S E R V I C E N O T E

Supersedes:
E8363B-03

E8363B PNA Microwave Network Analyzers

Figure 1: A3 Front Panel Interface Board Assy without the Bracket

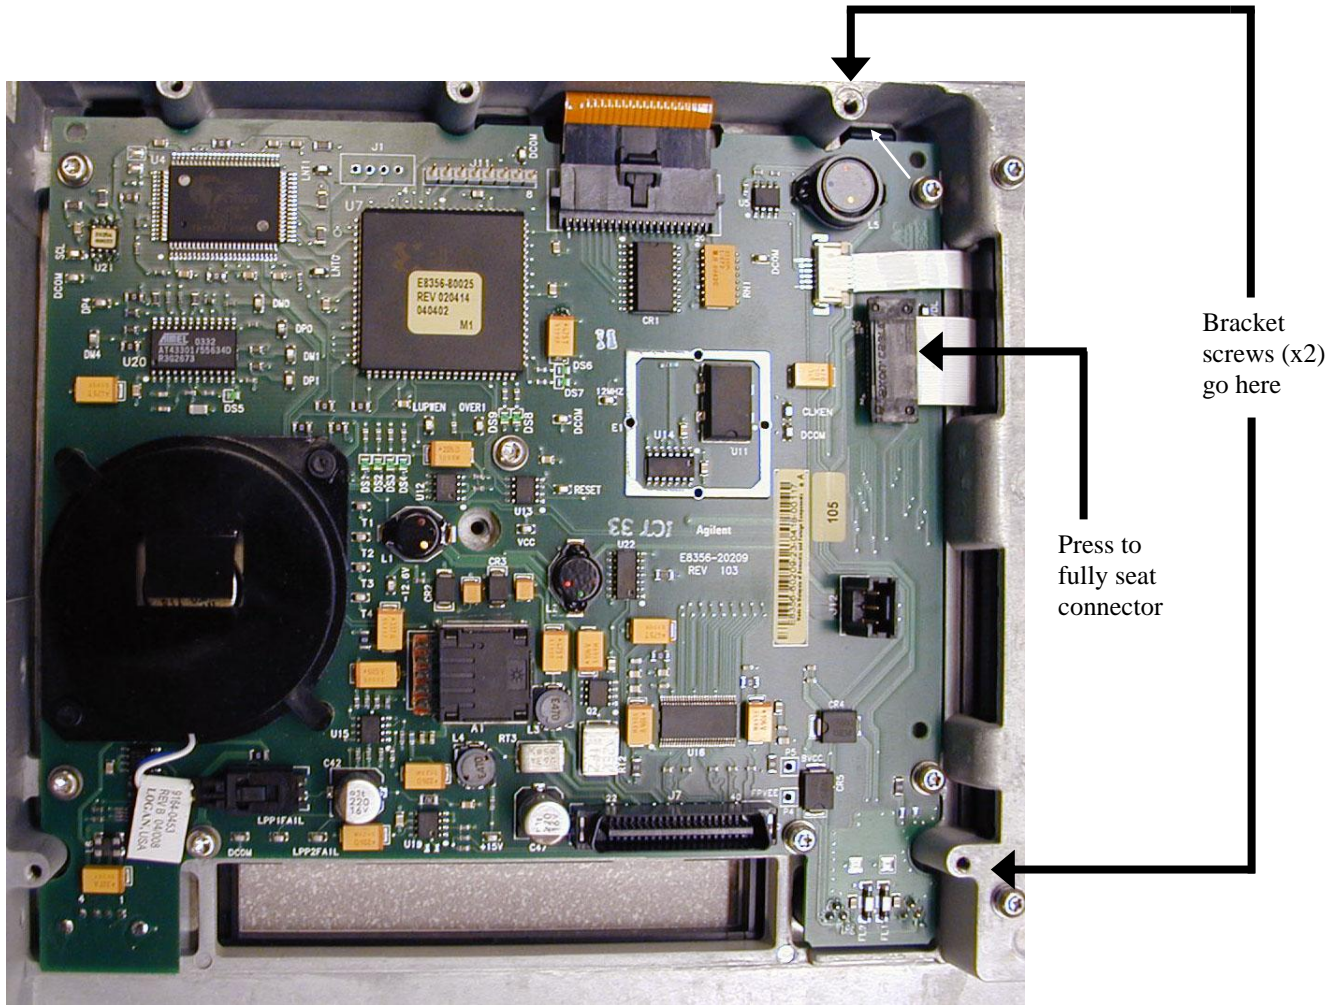
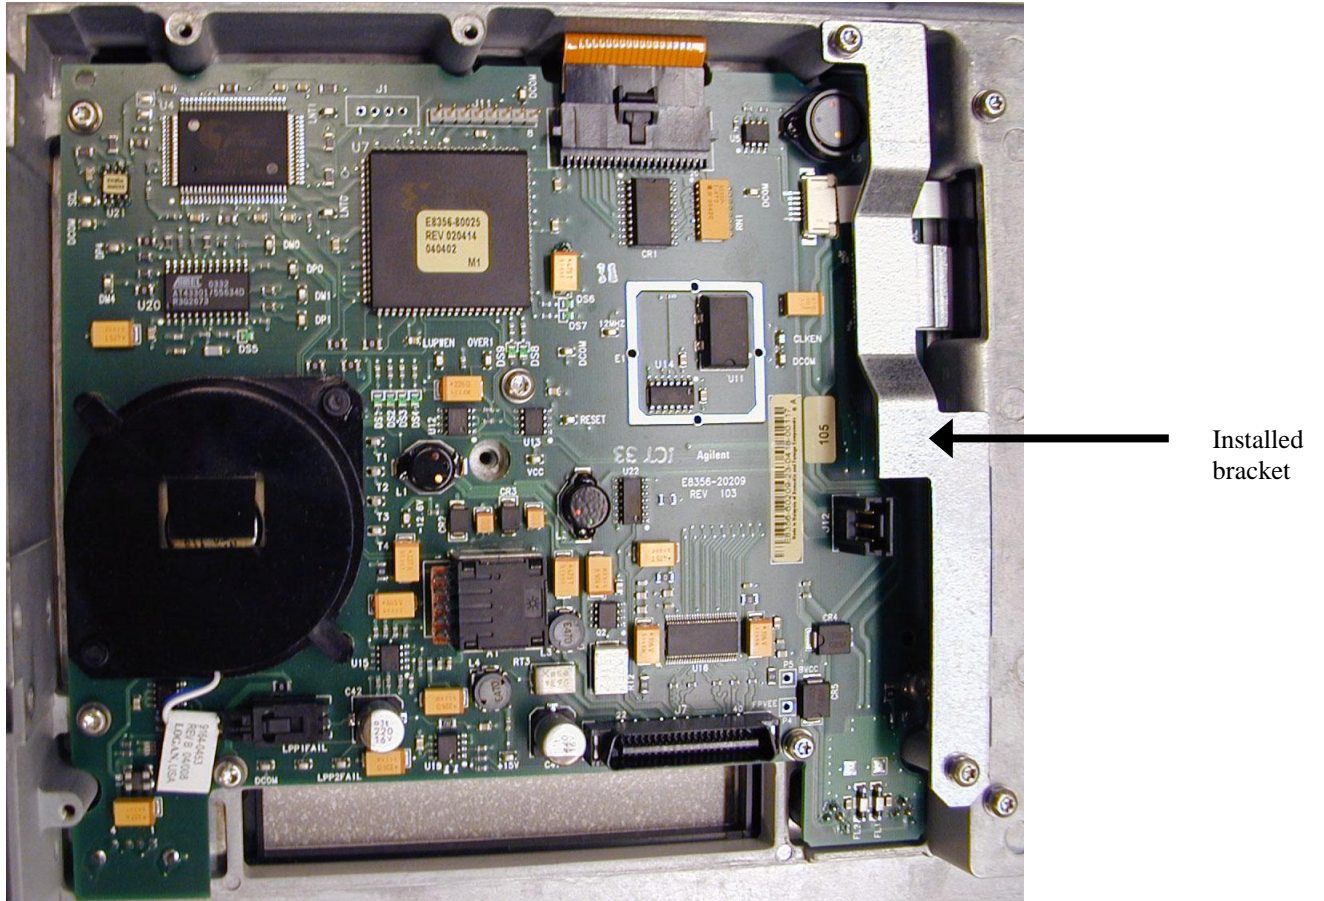
A connector of the ribbon cable (Agilent part number 8120-8409) that joins the front panel display to the front panel interface board can loosen, causing a display failure, unless a new bracket is installed. Because the failure rate has been very low, it is recommended that the bracket be installed only when there is an additional reason to remove the PNA front panel.

1. Refer to Figure 1 in this document:
 - Press down firmly on the ribbon cable's black connector.
 - Locate the two tapped holes for the bracket screws.
2. As shown in Figure 2 in this document, position the bracket so that its holes line-up with the two holes you located in the previous step.
3. Hand-start the two screws, and then torque both to 9 in-lbs.
4. Reinstall the PNA Front Panel by following the Service Guide instructions in the "Replacement Procedure." This is located on the same page as the "Removal Procedure" used previously in step 7.
